**5.0 Design Development**

### 5.1 - Discussion with Camden Council Design Officer 22.09 2010

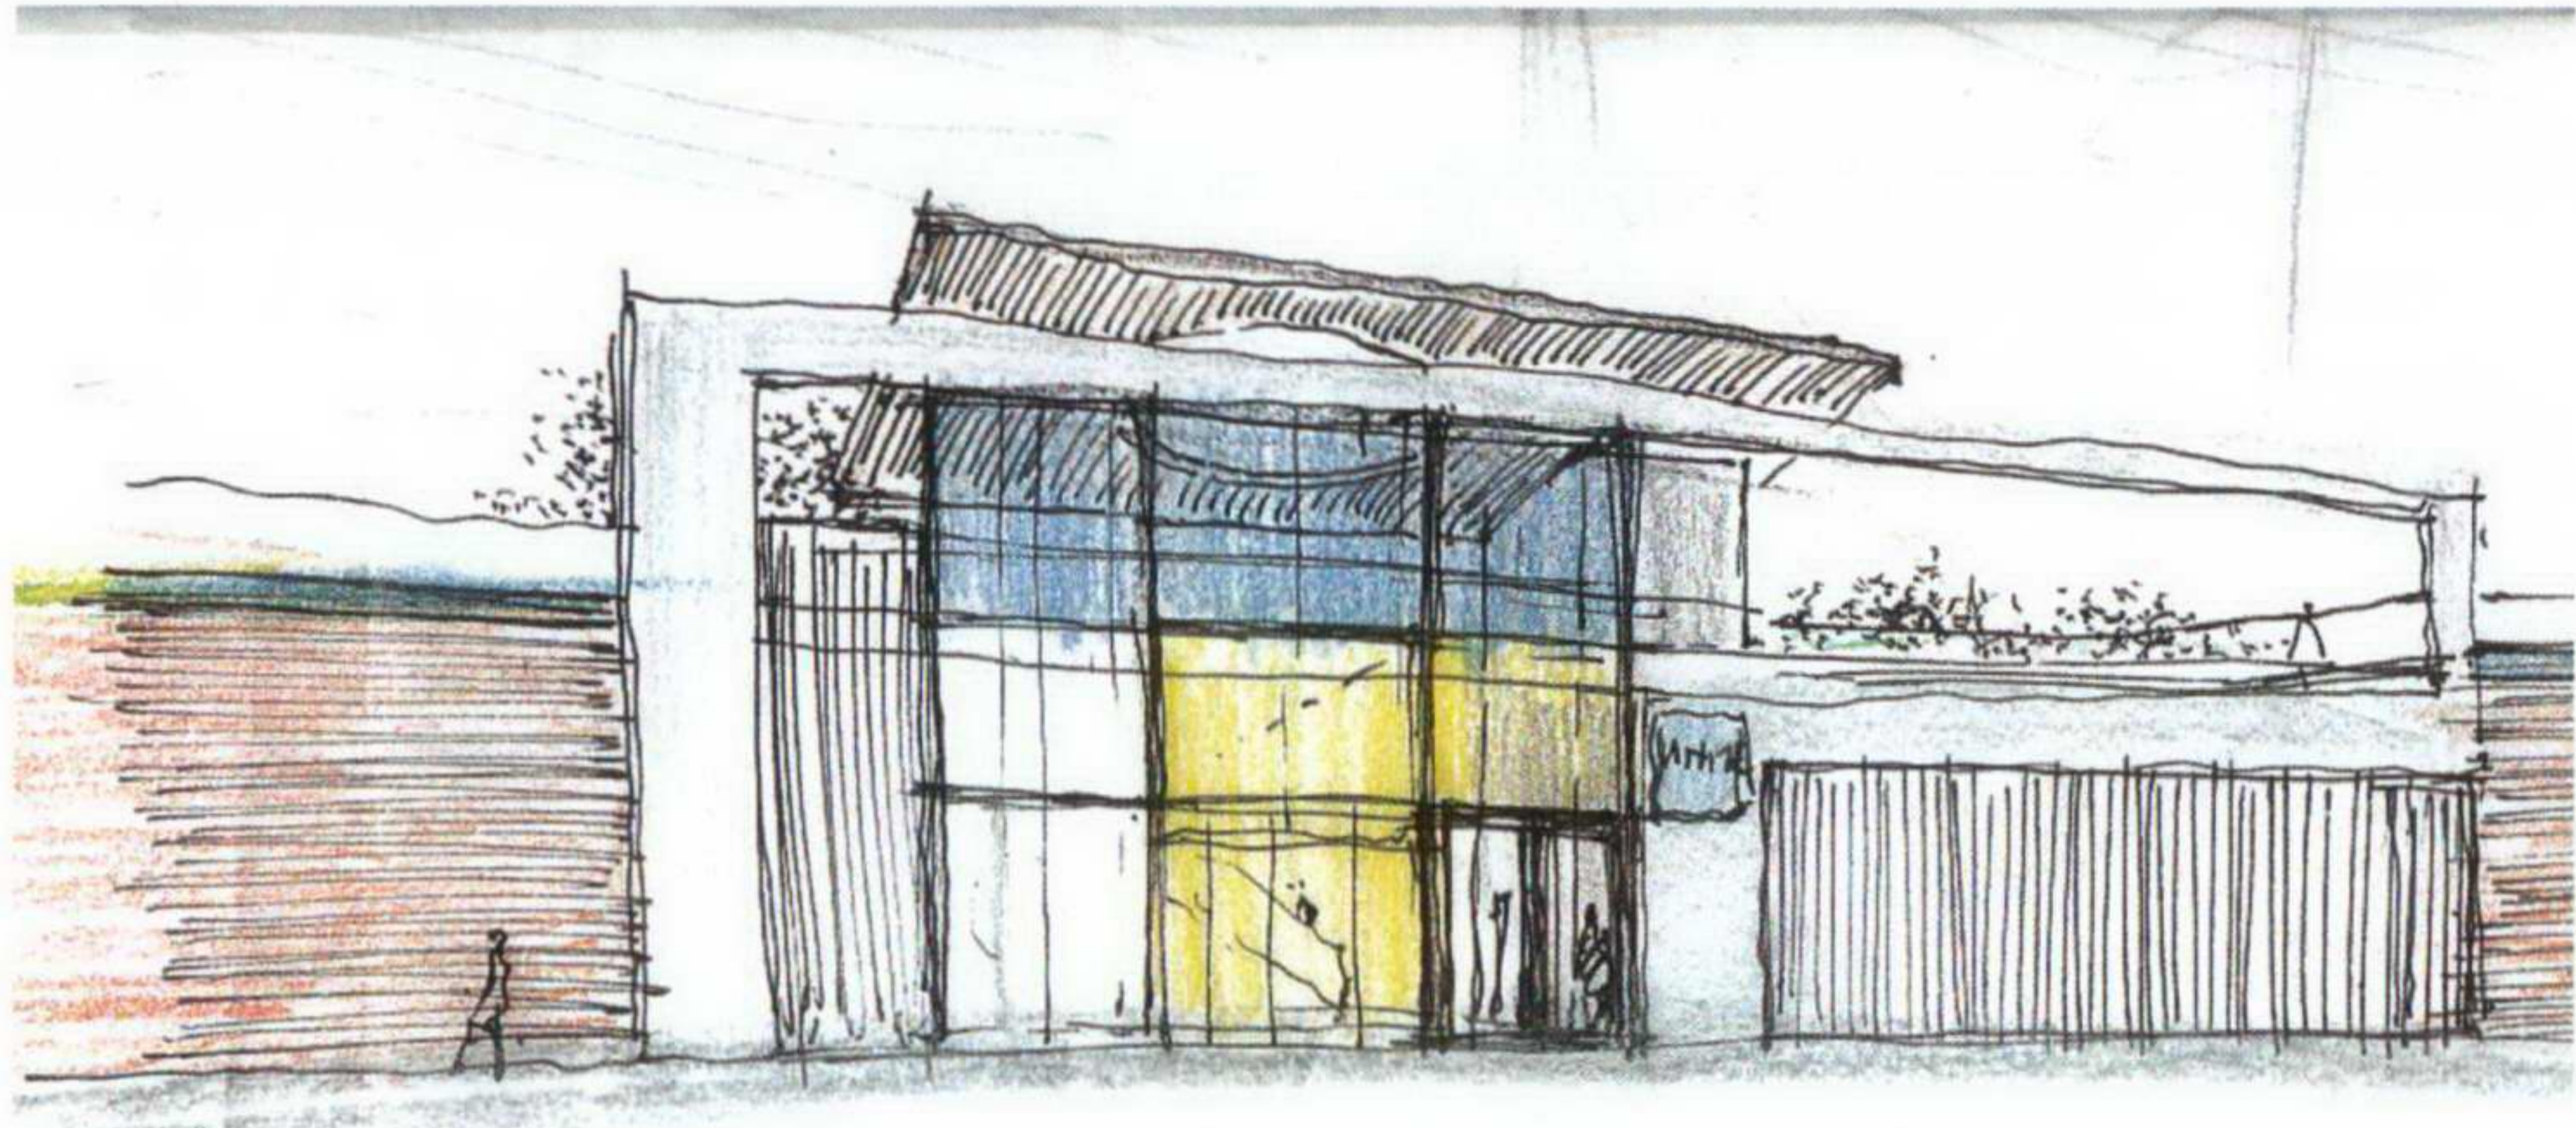
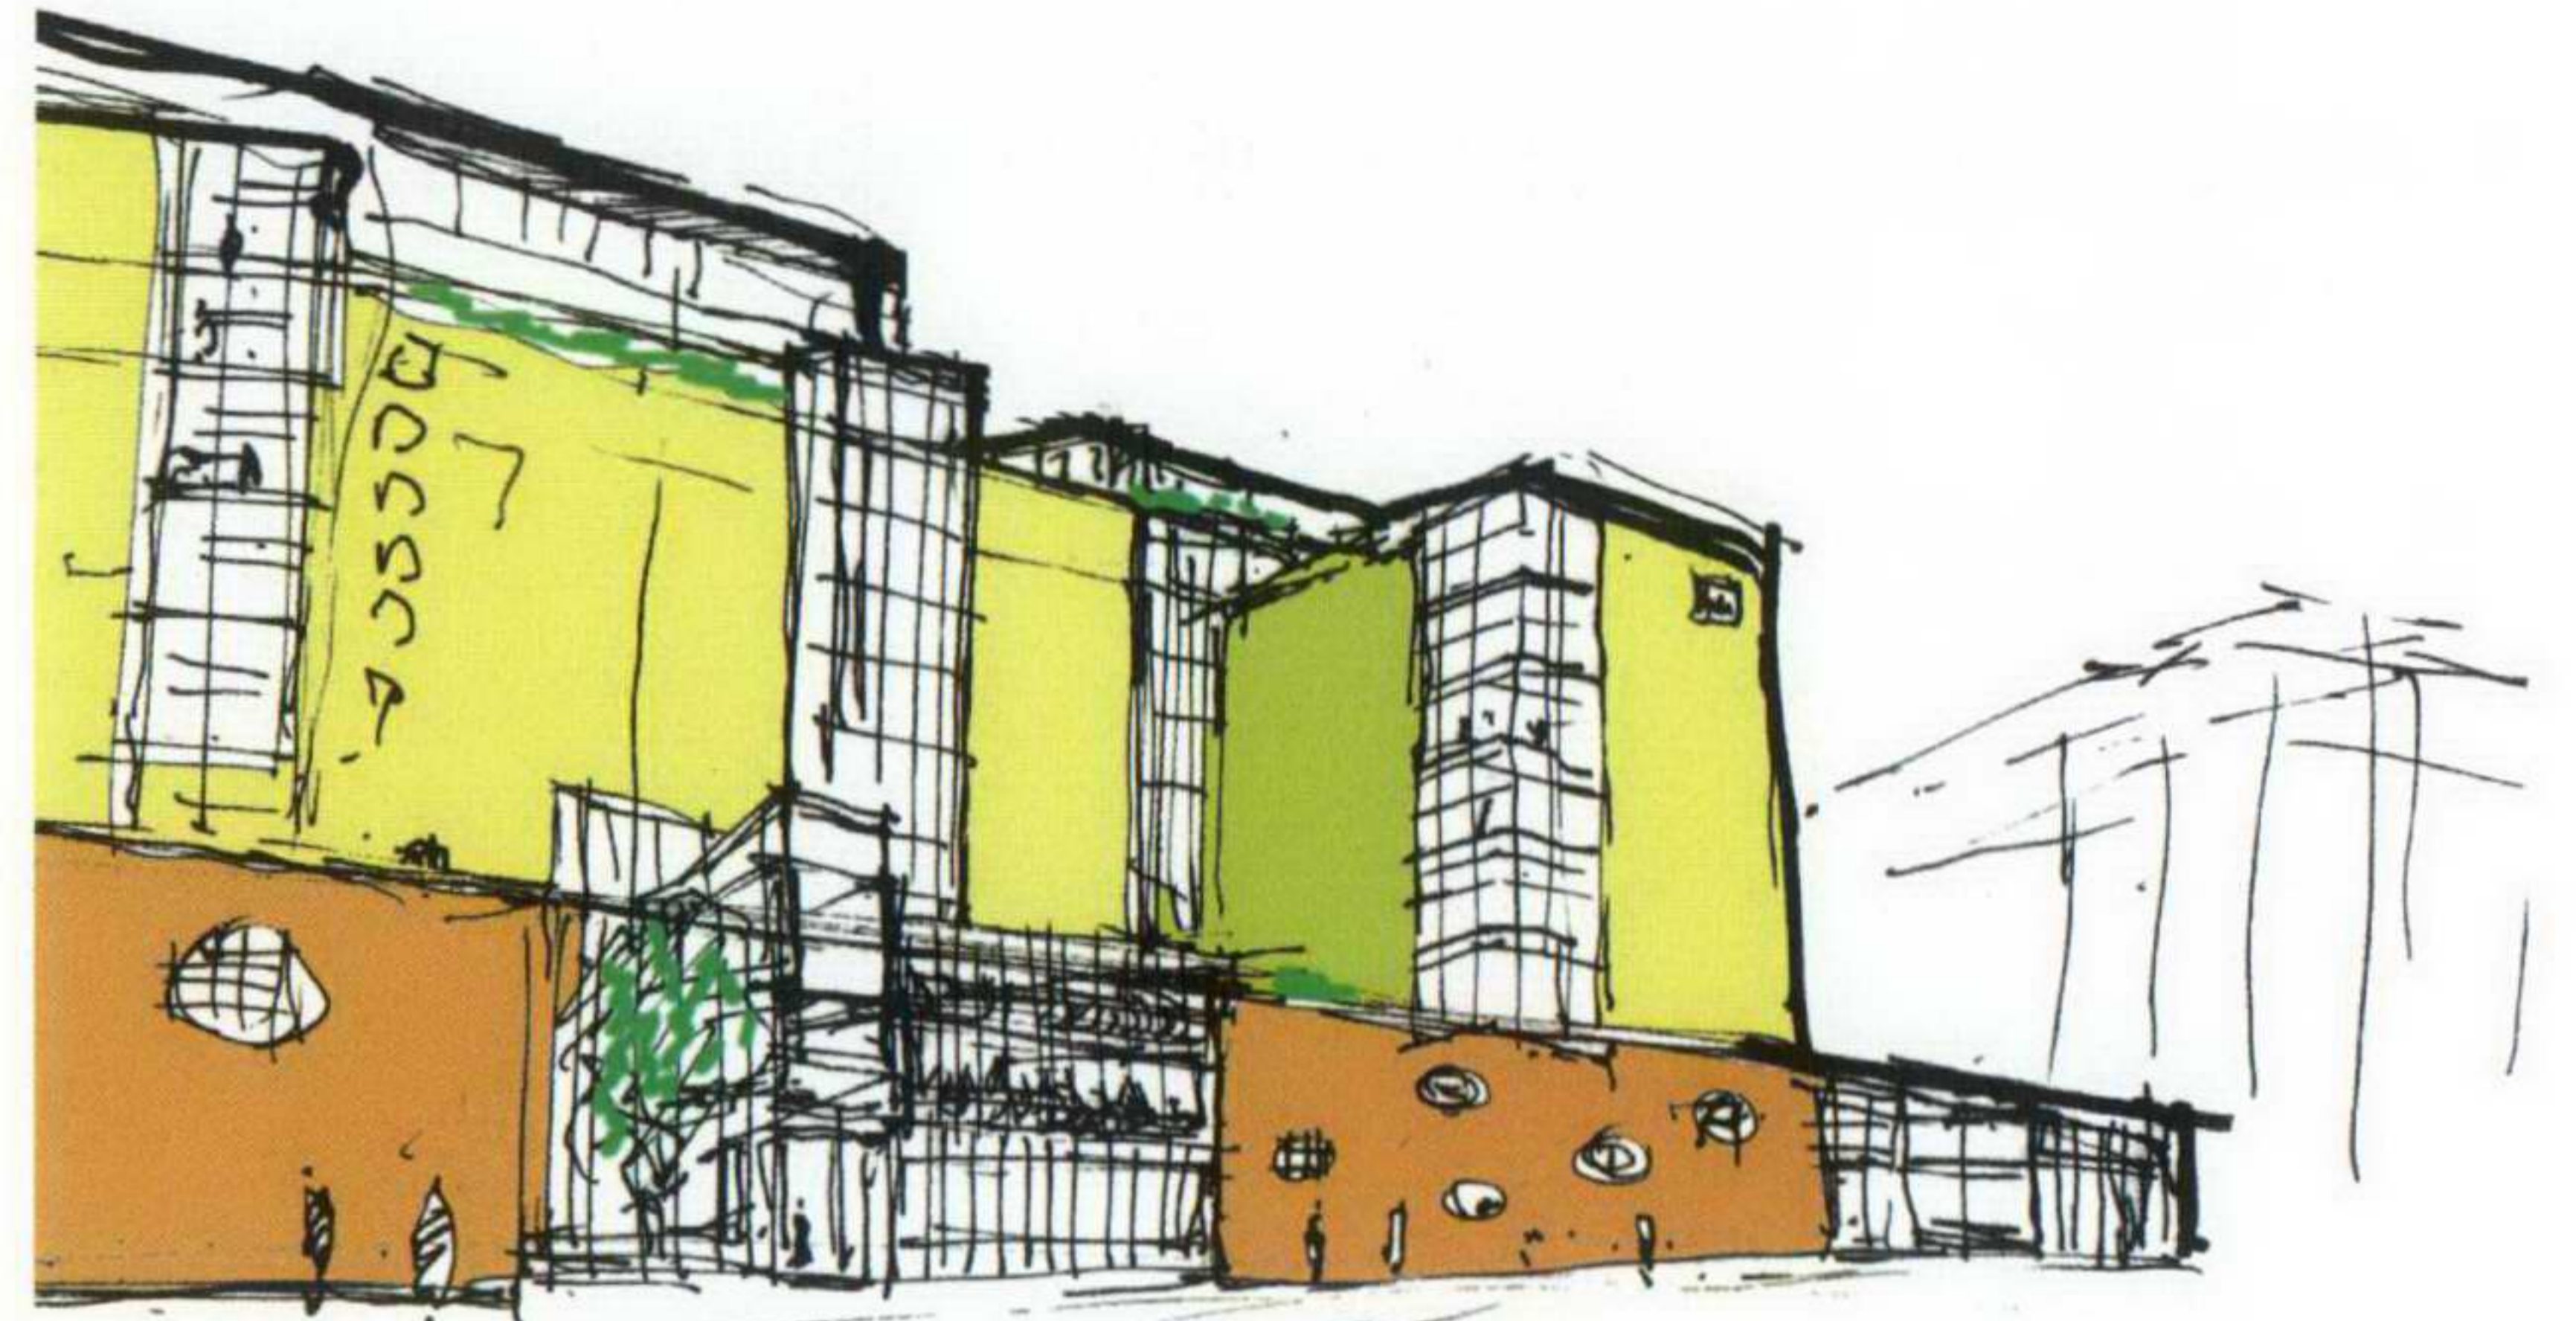
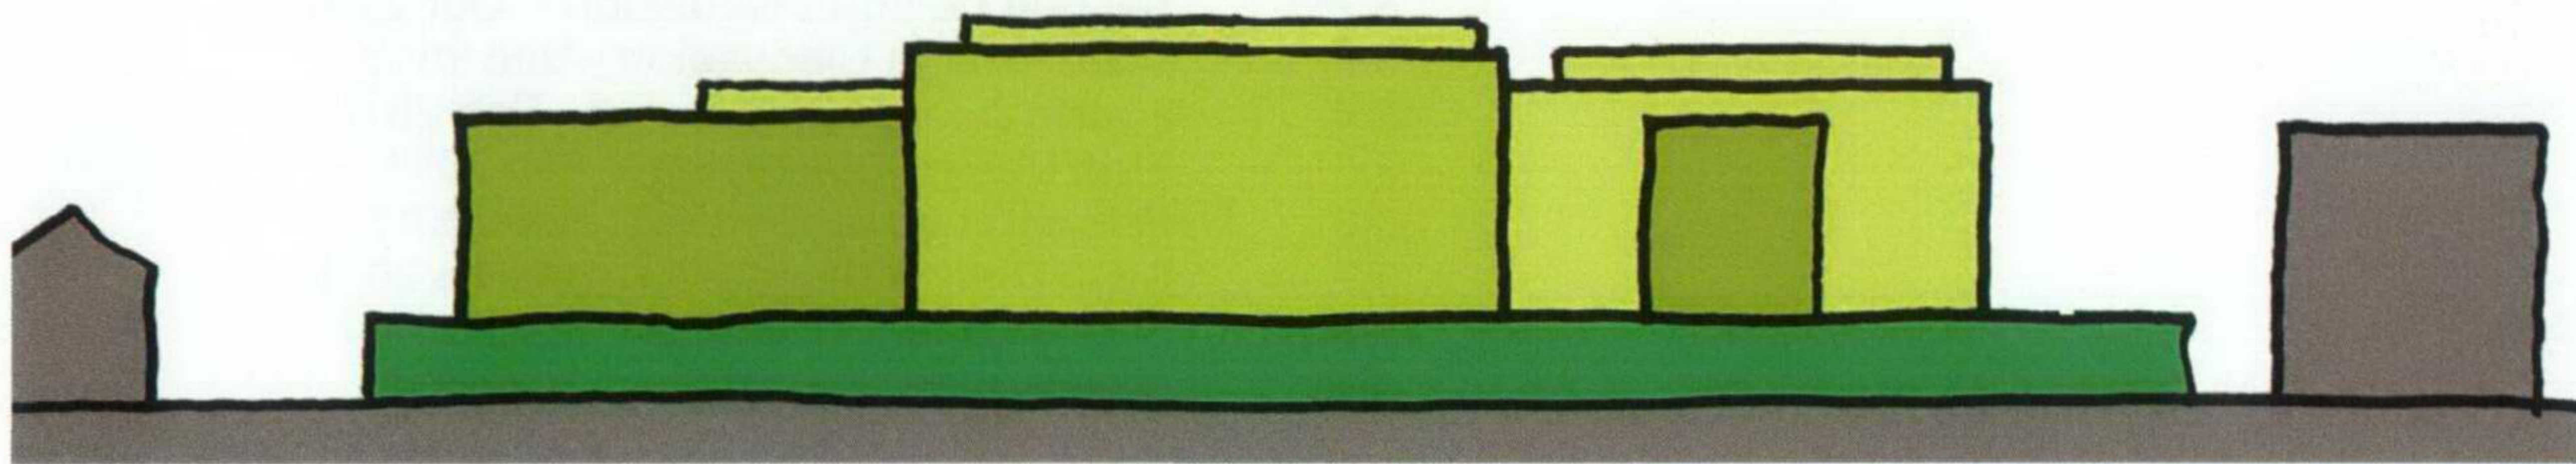
- The conceptual development and principles were discussed.
- The general revised layout of the site was considered to be successful in breaking up the mass of the building and in making a strong composition.

- The wall between the road and St Pancras Way was discussed in some detail. It was preferred that there should be more transparency in the wall. The builders merchants' activities bring a lot of life to the street and to hide it all behind a solid wall could detract from that. The Travis Perkins shop position should be more prominent.

- Whilst it was accepted that signage is necessary, it was preferred that it be well designed and not overbearing.
- The wall needs more detailed input.

- The elevations themselves need designing in a way that is in keeping with the building's concept. Further work is required on this point.
- It was suggested that in our approach to the podium level design we should promote as open a space as possible with a collegiate feel.

- We were encouraged to investigate how to express the modular nature of the design.
